Mack LR Models - FSB 810-004, Back Of Cab Crack, Repair

FSB 810-004, Back of Cab Crack, Repair

(July 2020)

Certain Mack LR model trucks may experience crack on the back of cab. Mack Trucks determine to replace the existing panel kit of engine cover with new panel kit.

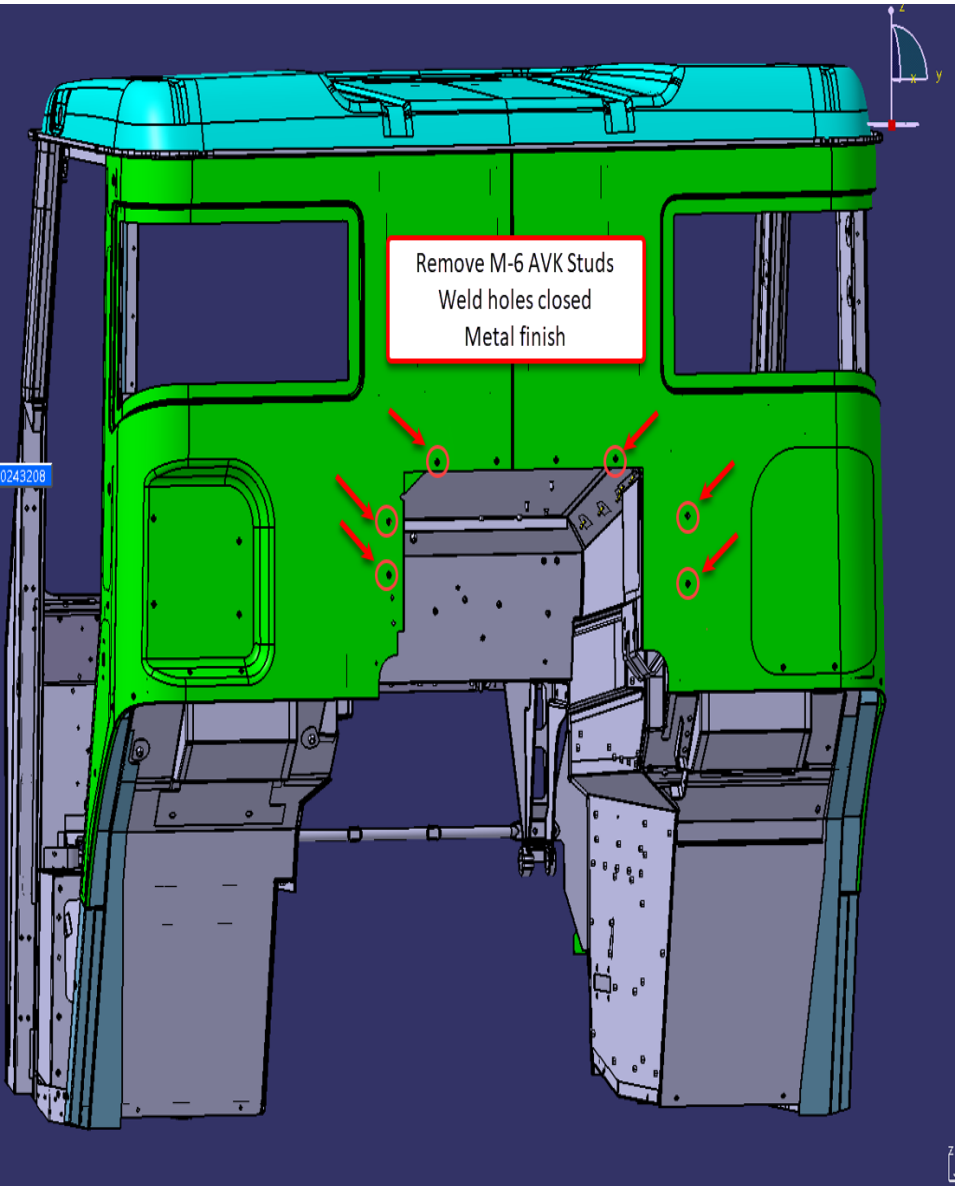
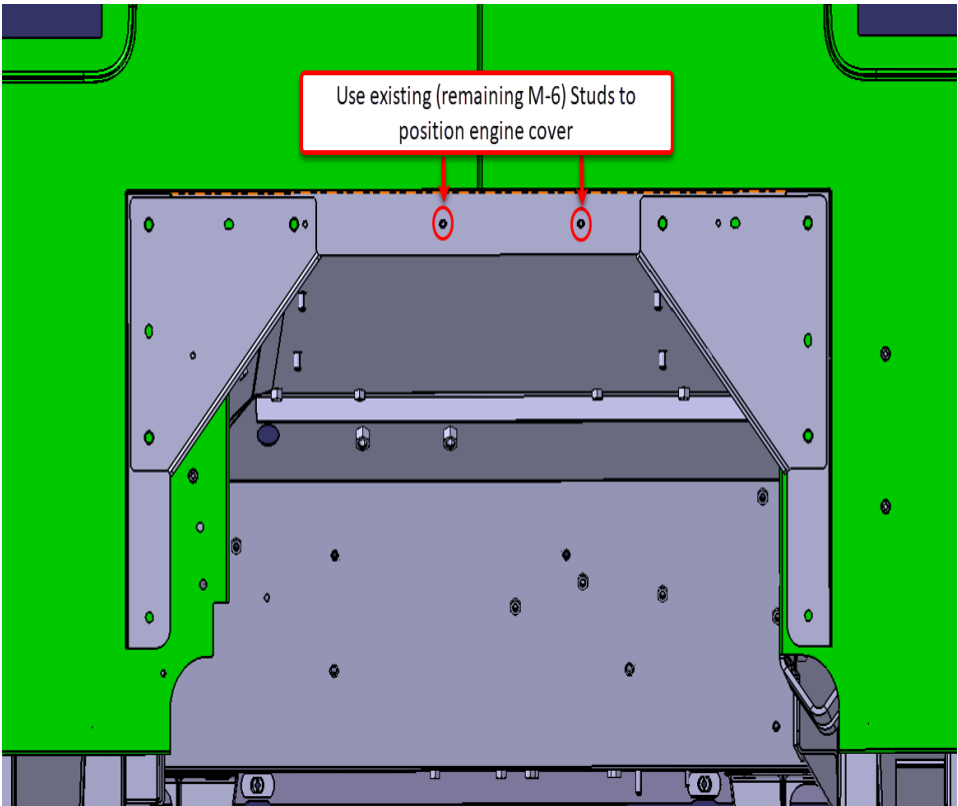
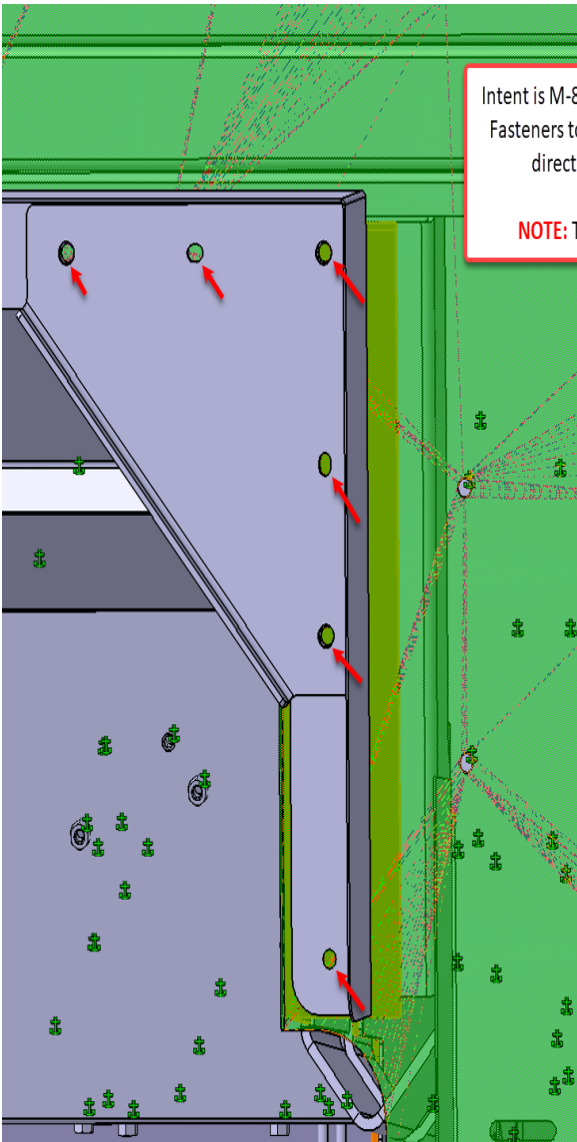
Drill a stop hole at the end of the crack, weld, and repair the cab before installing the new bracket

Intent is M-8 Rivet nuts and fasteners in all other locations
Fasteners to run thru the saddlebag upright panel that is
directly behind the rear wall outer skin panel.

NOTE: This would be valid for the LH side as well.

T8159770

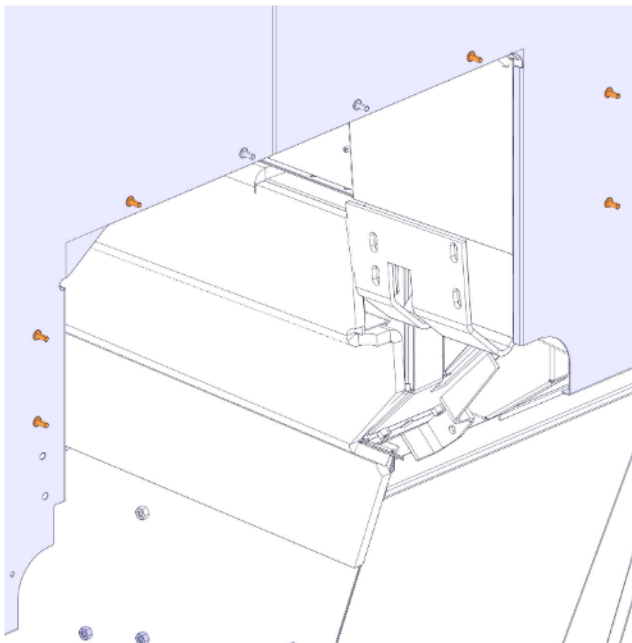
- 9 Drill a stop hole at the end of crack. Weld and repair the crack on the back of cab.

T8159769

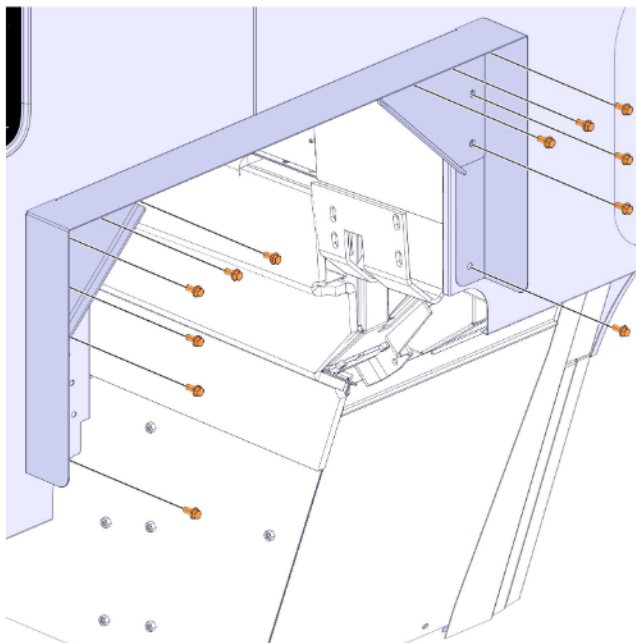
18 Install the fasteners.

Note: The fasteners to run through the saddlebag upright panel that is behind the outer skin panel of rear wall.
